**SPRINGFIELD CITY HALL \* LIBRARY MEETING ROOM \* 225 FIFTH STREET \* 541-726-3753**

*PUBLIC MEETING MINUTES*  
November 18, 2009

## Glenwood Refinement Plan Update

### Citizen & Technical Advisory Committee Meeting

# Refined Land Use Framework and District Street Grid

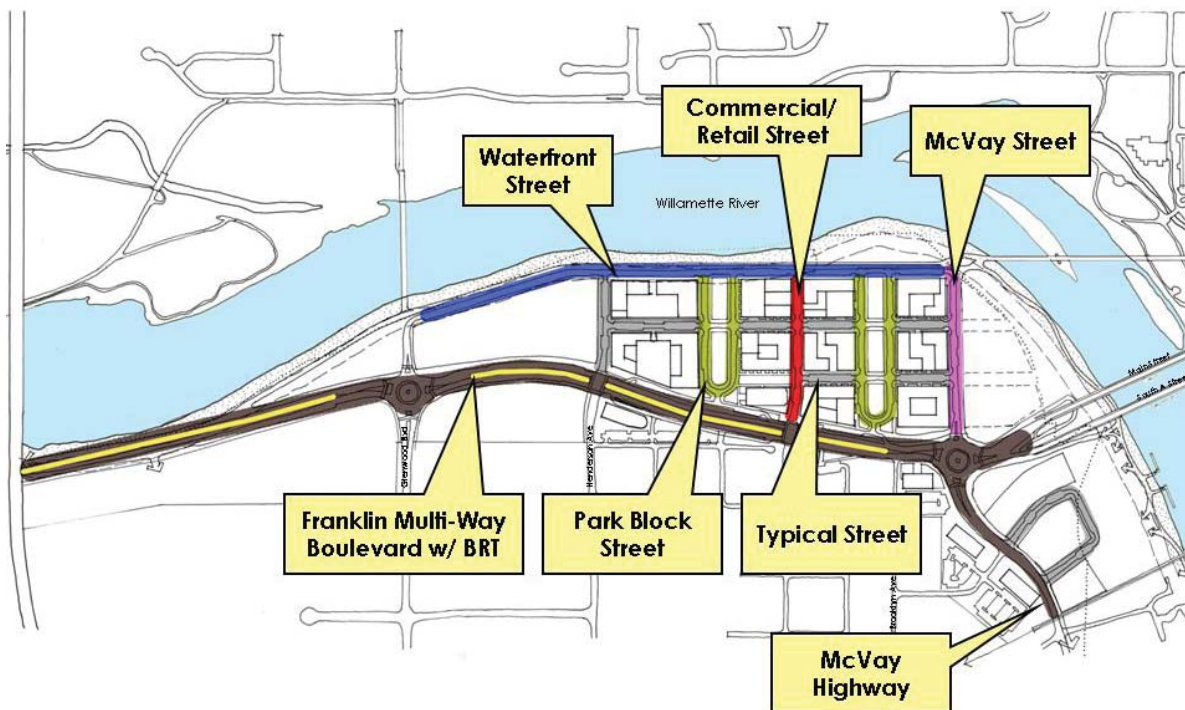
- I am somewhat concerned with the degree to which park land has been reduced from what has been anticipated in previous plans—the existing Glenwood RP and the Willamalane Comp. Plan both anticipated a riverfront park with metro or regional significance. Your proposed park blocks and riverfront linear park are substantial, so they go a long way toward meeting the need—and maybe all the way. I think though that a modest move back toward the amount of park land that was shown on your first draft may be a good idea. Maybe a slight widening could occur at the SE portion of the area you're showing as HH and/or the area between the highway bridges and the RR bridge. Good work.

- I absolutely prefer the grid streets and park blocks.
- If all service access is on a 'typical street', then you will need more than 10' wide lanes for large delivery trucks.

- I don't like the design of the street along the river. I think there needs to be a bike lane on the road and a multi-use path that meanders along the river. Get people in the park/greenway area. Also need street parking to allow for better access. You should concentrate on a narrow green-street design along the river.

- Don't like the northern/waterfront street.
- No road on the river. It's too close and too car oriented.
- As a homeowner in the residential core I consider my standing in the riverfront area limited to having some natural, publicly accessible use areas. I am concerned about the effect of the potential high-traffic flow and parking demands, as well as the separation from the area south of Franklin Boulevard.

- Proposed bike/ped bridge is blocking the view of the river from development parcels.
- Waterfront street does not need auto's, put less emphasis on the auto. Street should be pedestrian only. I think that housing units should back right to the river.

- 60% of this plan is for parks and streets, this is too high. A solution would be to remove a single east-west street in the middle of the development area
